Potomac Medical Plaza
1550 S. Potomac Street
Aurora, CO 80012
Suite 320

QC Kinetix

Sheet Contents	WASTE PLAN AND ISOMETRICS
Project Team	21386
Project Number	
Sheet Mark	P1.2

City of Aurora Building Division
Reviewed for Code Compliance
Approved as Noted: *Bobby McKinzie*
Date: **Oct 03, 2021**
2015 INTERNATIONAL CODES & 2020 NEC

DEMOLITION PLAN

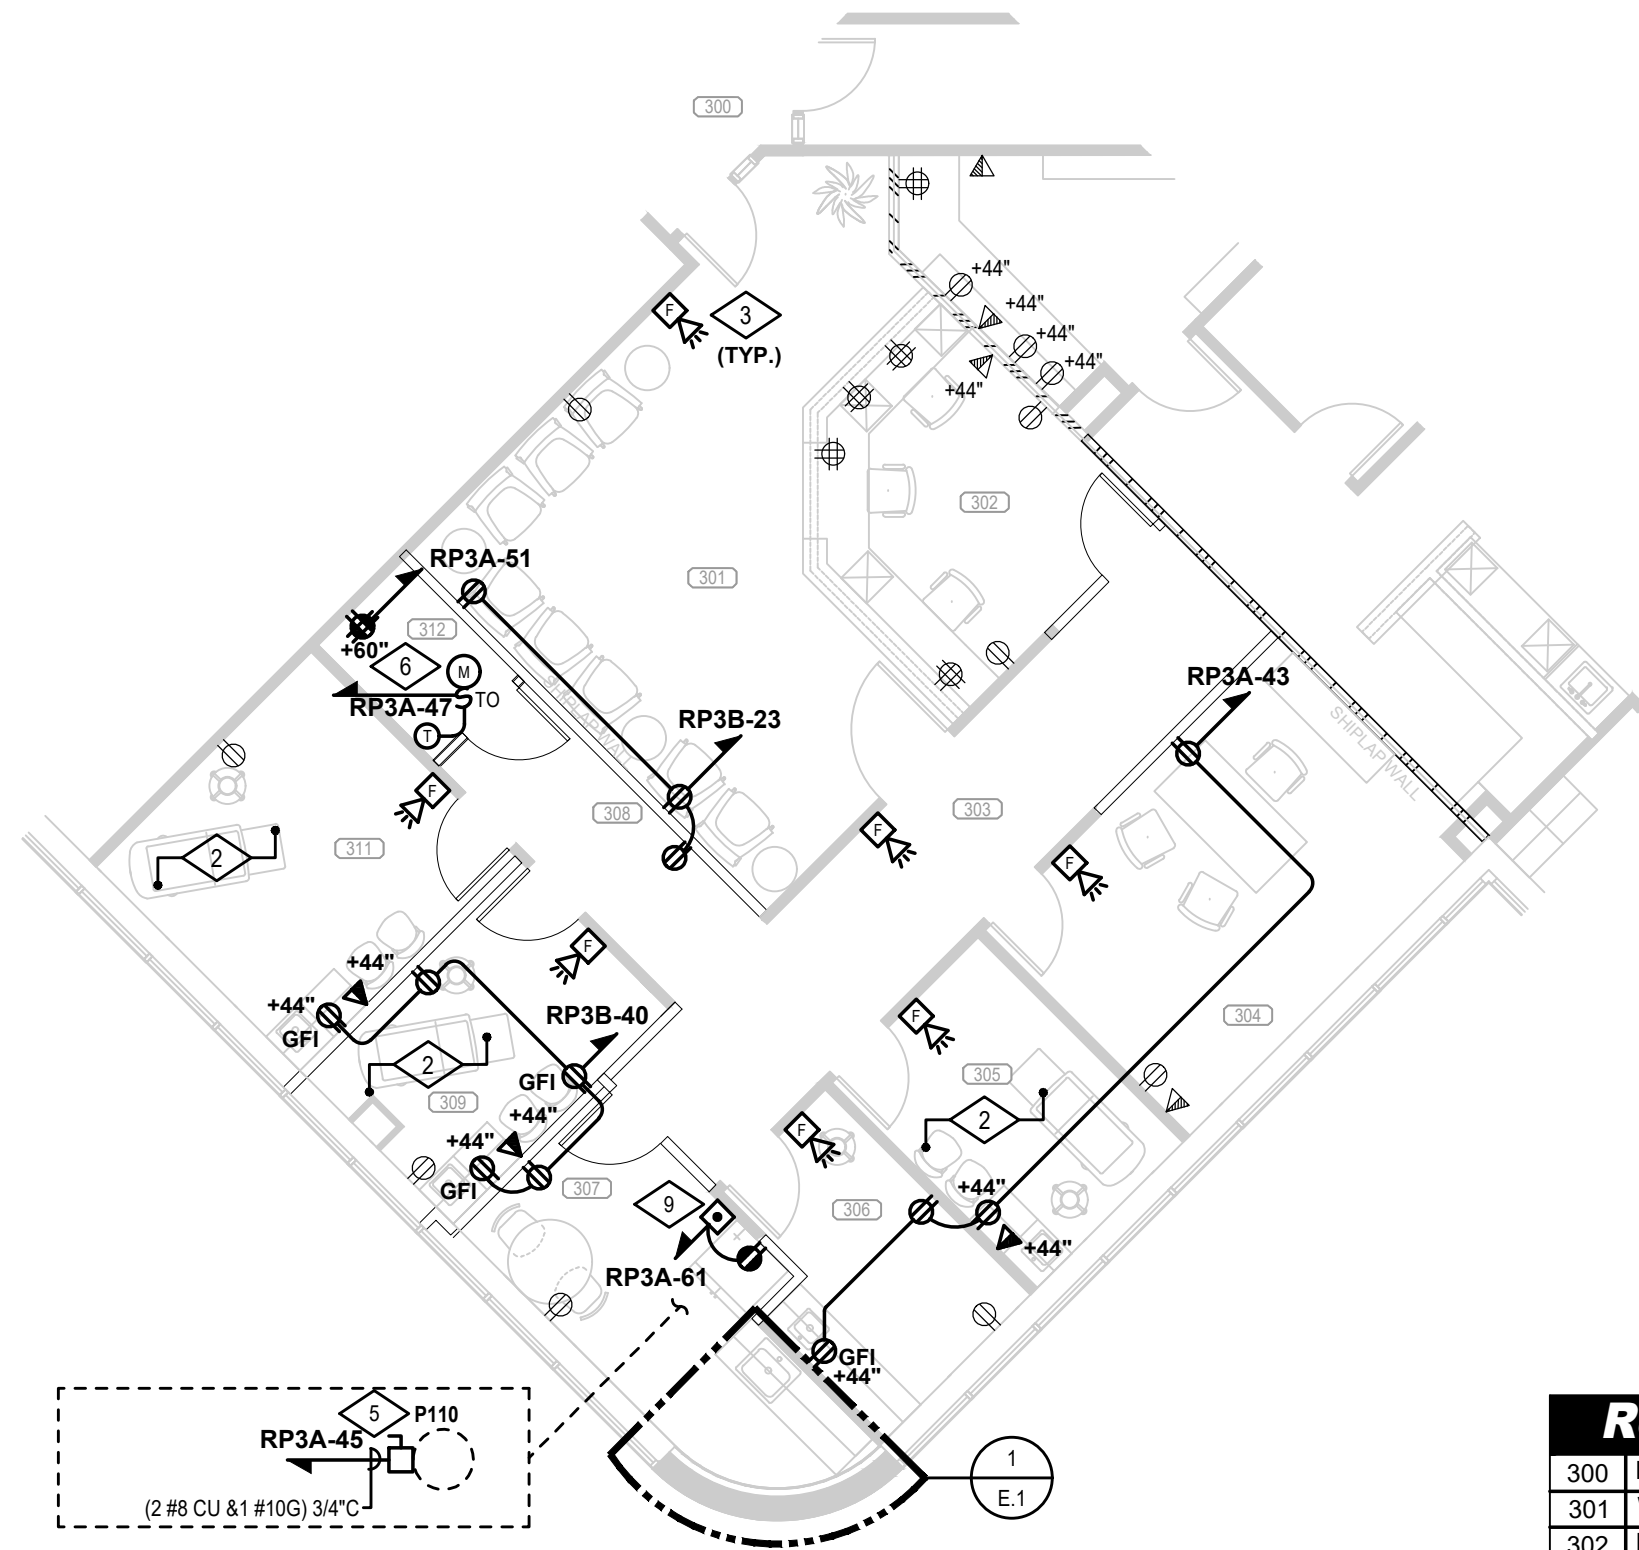
SEPARATE FIRE ALARM PERMIT REQUIRED:
Due to the proposed work the general contractor is required to obtain the services of a fire alarm contractor to determine if a separate alarm permit is required. If it is determined that the spacing of the fire alarm devices is not in compliance, then a separate fire alarm permit is required. Approval of the documents is required prior to system installation or any request for inspection. A certificate of occupancy or final approval cannot be issued by the Building Division without this fire protection system. **2015 IFC, Section 105.7.6.**

TYPICAL DEVICE LABELING DETAIL

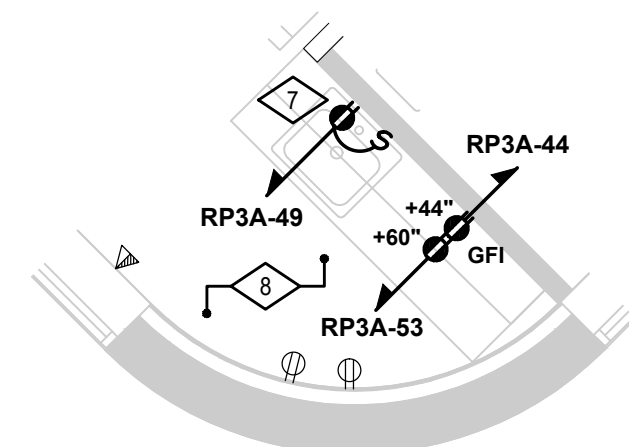
Every circuit and circuit modification shall be legibly Identified as to it's clear, evident and specific purpose or use. The identification shall include an approved degree of detail that allows each circuit to be distinguished from all others. 2020 NEC 408.4

ENLARGED BREAK AREA

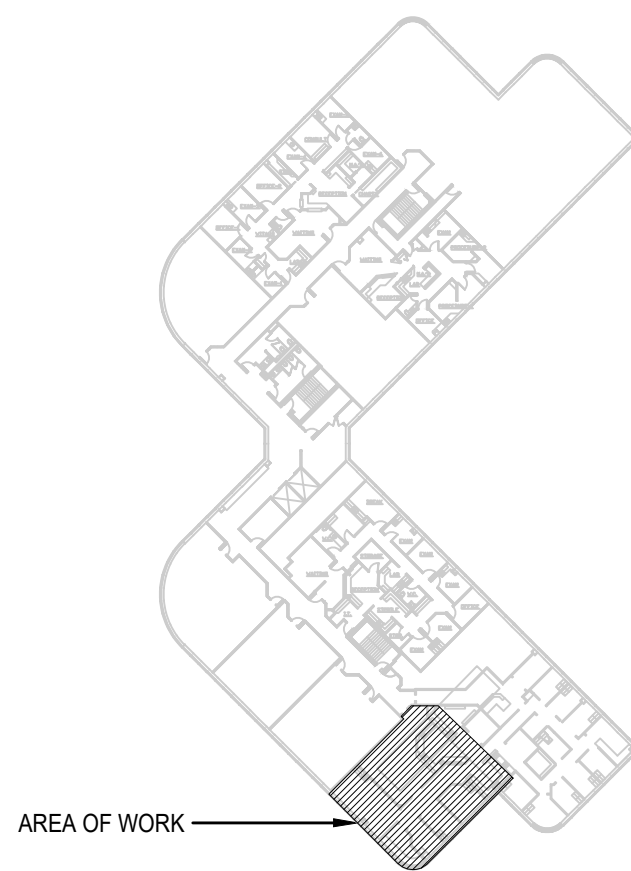
Install electrical connections per 2020 NEC 110.14, Identify disconnects per 2020 NEC 110.22 and provide working space around Electrical equipment per 2020 NEC 110.26

Provide Emergency Illumination Equipment That complies with 2020 NEC 700.12(F) or NEC 700.

Suspended Ceiling Systems and the Luminaires They support shall meet the requirements of 410.36(B) 2020 NEC

Wiring in air handling space must comply with 2020 NEC 300.22. Firestop penetrations per 2020 NEC 300.21. Secure and support equipment per 2020 NEC 300.11.

PARTIAL EXISTING ONE-LINE DIAGRAM

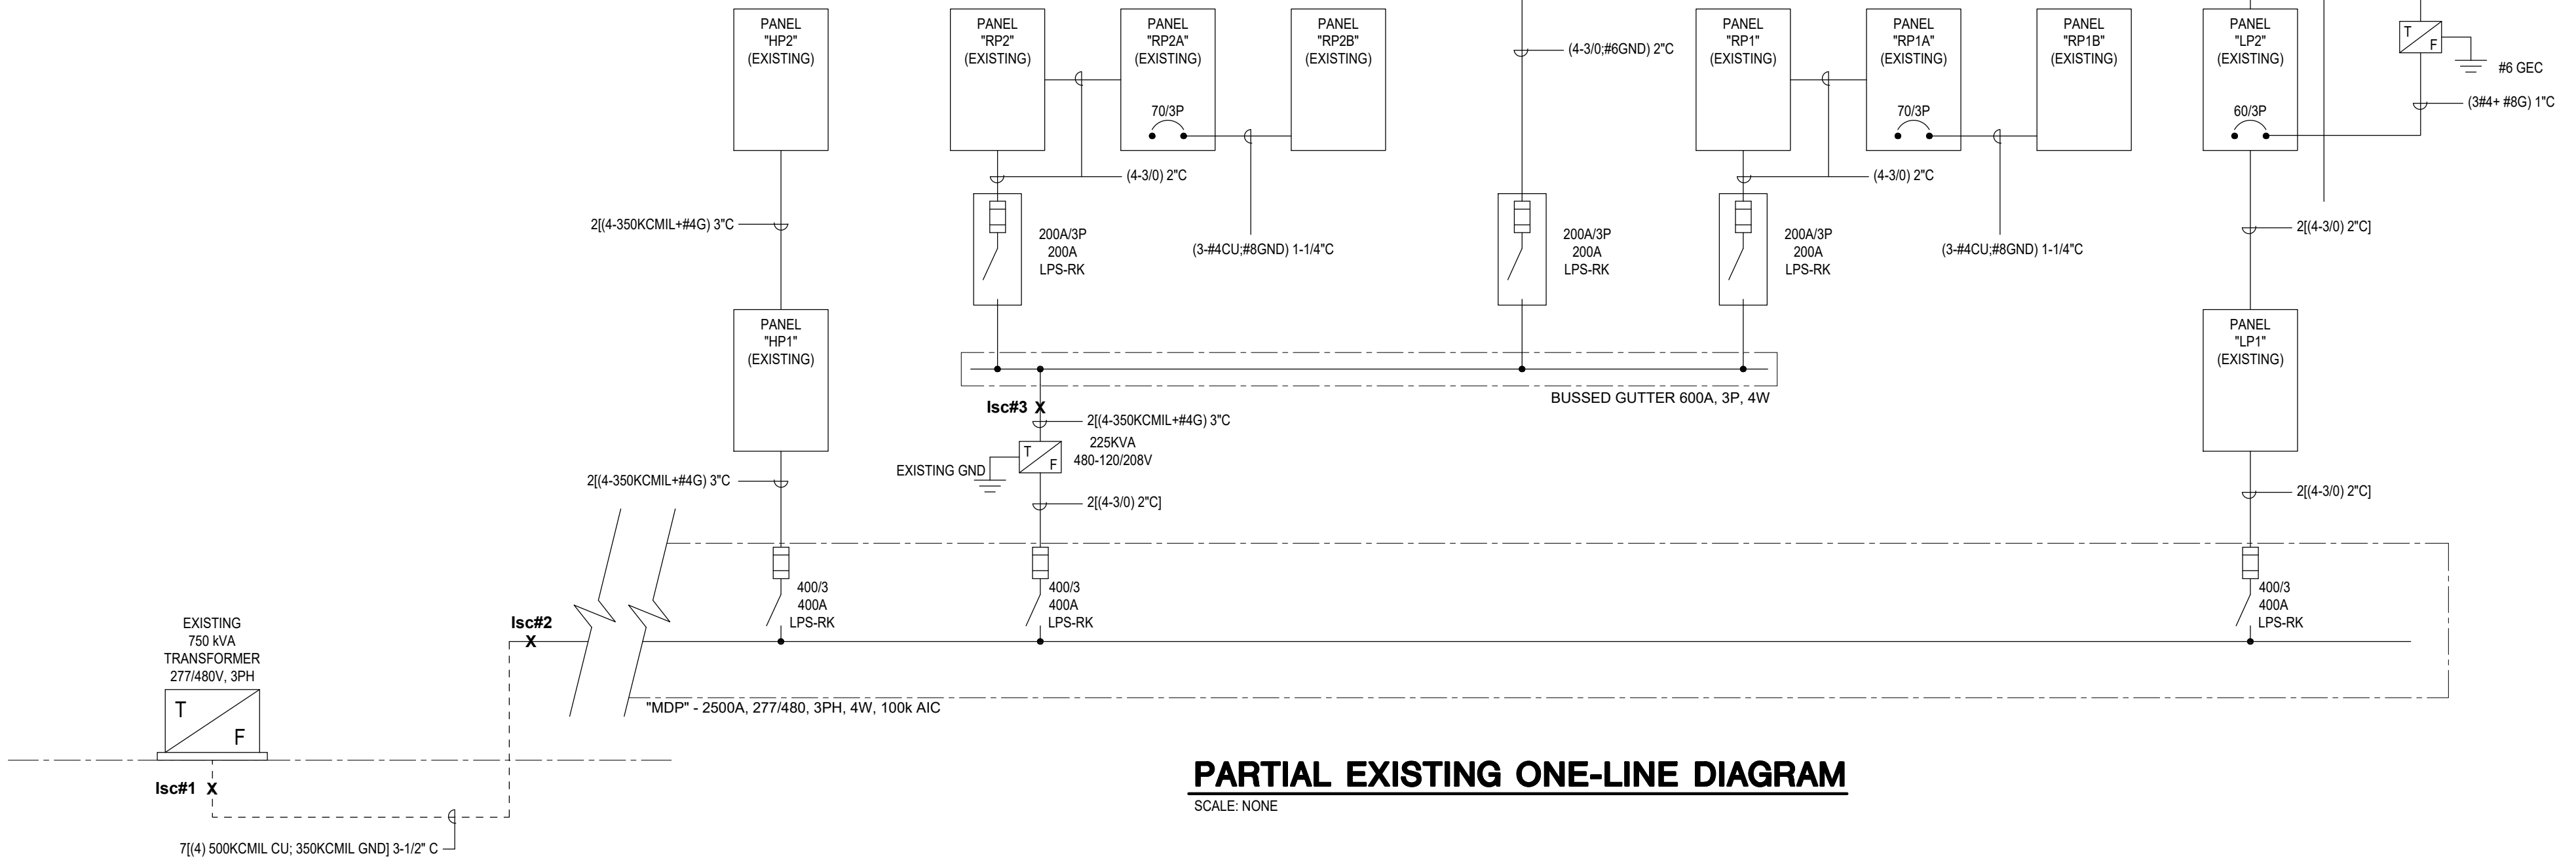
Every circuit and circuit modification shall be legibly identified as to it's clear, evident and specific purpose or use. The identification shall include an approved degree of detail that allows each circuit to be distinguished from all others. 2020 NEC 408.4

Service Equipment shall be permanently And legibly marked to show the available Fault current and date. 2020 NEC 110.24(A)(B)
